Project	IEEE 802.16 Broadband Wireless Access Working Group < http://ieee802.org/16 >	
Title	Rotated Codebooks for Closed-loop MIMO	
Date Submitted	2005-05-03	
Source(s)	Chan-Byoung Chae, Wonil Roh, Sung-Ryul Yun, Kyunbyoung Ko, JeongTae Oh, Hongsil Jeong, Seungjoo Maeng, Panyuh Joo, Jaeho Jeon, Jerry Kim, Soonyoung Yoon, K. Sivanesan, Marcos Katz, DS Park	cb.chae@samsung.com
	Samsung Electronics Co., Ltd.	
	Qinghua Li, Xintian Eddie Lin Intel Corporation	
Re:		
Abstract		
Purpose	Adoption of proposed changes into P802.16e Crossed-out indicates deleted text , <u>underlined blue indicates new text change to the Standard</u>	
Notice	This document has been prepared to assist IEEE 802.16. It is offered as a basis for discussion and is not binding on the contributing individual(s) or organization(s). The material in this document is subject to change in form and content after further study. The contributor(s) reserve(s) the right to add, amend or withdraw material contained herein.

Rotated Codebooks for Closed-loop MIMO

Fig 1. BER/FER Performance for Codebook based CL-MIMO w/o Rotation Matrix R

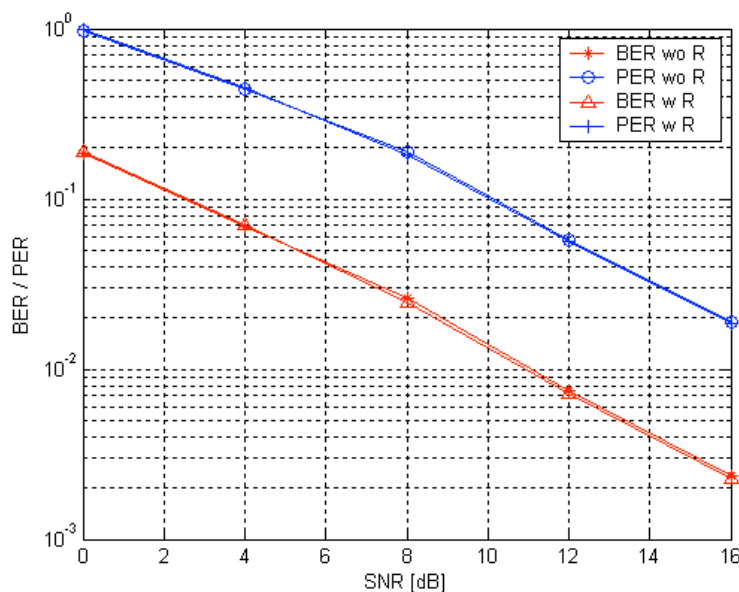
Fig. 1 shows the long term BER/FER performance for codebook based closed-loop MIMO system with different vector codebooks mentioned above. As can be seen, there is no performance difference at all. In addition, all transmit antenna will be used for every channel use.
